Access Compliance Report

Public Rights-of-Way

(Curb Ramps)

Intersection ID: 49239	Main Street: W_SUGAR_CREEK_RD	Cross Street: HUBBARD_FALLS_DR	Location: W
ADA ID: A260F75FF563	Ramp Type: Perp	Initial Pass/Fail: Fail	Overall Compliance: No
		Severity Score: 25

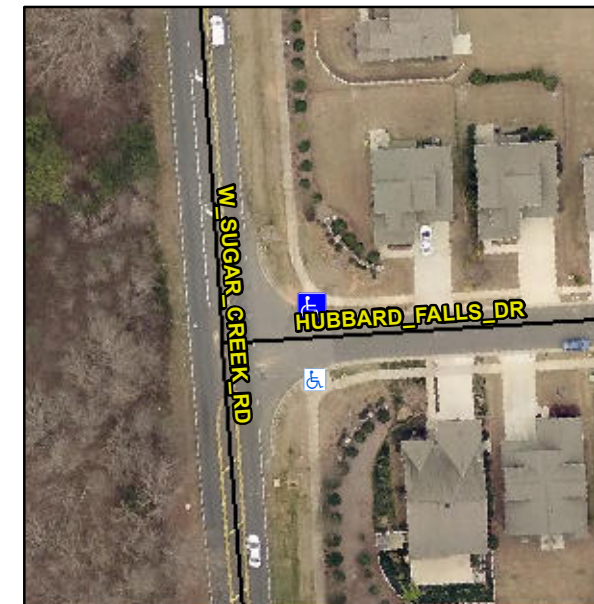
Not Found, R304.2.2

Compliance	Description	Data	Compliance	Description	Data
N/A	Ramp Length (in)	61.0	No	Ramp Slope (%)	13.9
Yes	Ramp Width (in)	48.0	Yes	Ramp XSlope (%)	1.3
N/A	Flare Type LT	N/A	N/A	Flare Type RT	N/A
N/A	Flare Slope LT (%)	N/A	N/A	Flare Slope RT (%)	N/A
N/A	Flare Traversable LT?	N/A	N/A	Flare Traversable RT?	N/A
N/A	Landing Length (in)	N/A	N/A	DWS Provided?	N/A
N/A	Landing Width (in)	N/A	N/A	DWS Contrast?	N/A
N/A	Landing Slope (%)	N/A	N/A	DWS Length (in)	N/A
N/A	Landing X Slope (%)	N/A	N/A	DWS Full Width?	N/A
N/A	Landing Curb? (Y/N)	N/A	N/A	DWS Offset (in)	N/A
N/A	Shared Landing?	N/A			
N/A	Gutter Ponding?	N/A	N/A	Gutter Slope (%)	N/A
N/A	Gutter Lip Ht (in)	N/A	N/A	Gutter X Slope (%)	N/A
N/A	Painted X Walk1?	No	N/A	Painted X Walk2?	N/A
	X Walk 1 Direction	To S		X Walk 2 Direction	N/A
N/A	X Walk 1 Width (in)	N/A	N/A	X Walk 2 Width (in)	N/A
	X Walk 1 Slope (%)	5.0		X Walk 2 Slope (%)	N/A
	X Walk 1 X Slope (%)	2.1		X Walk 2 X Slope (%)	N/A

Remove & Replace Entire Ramp.
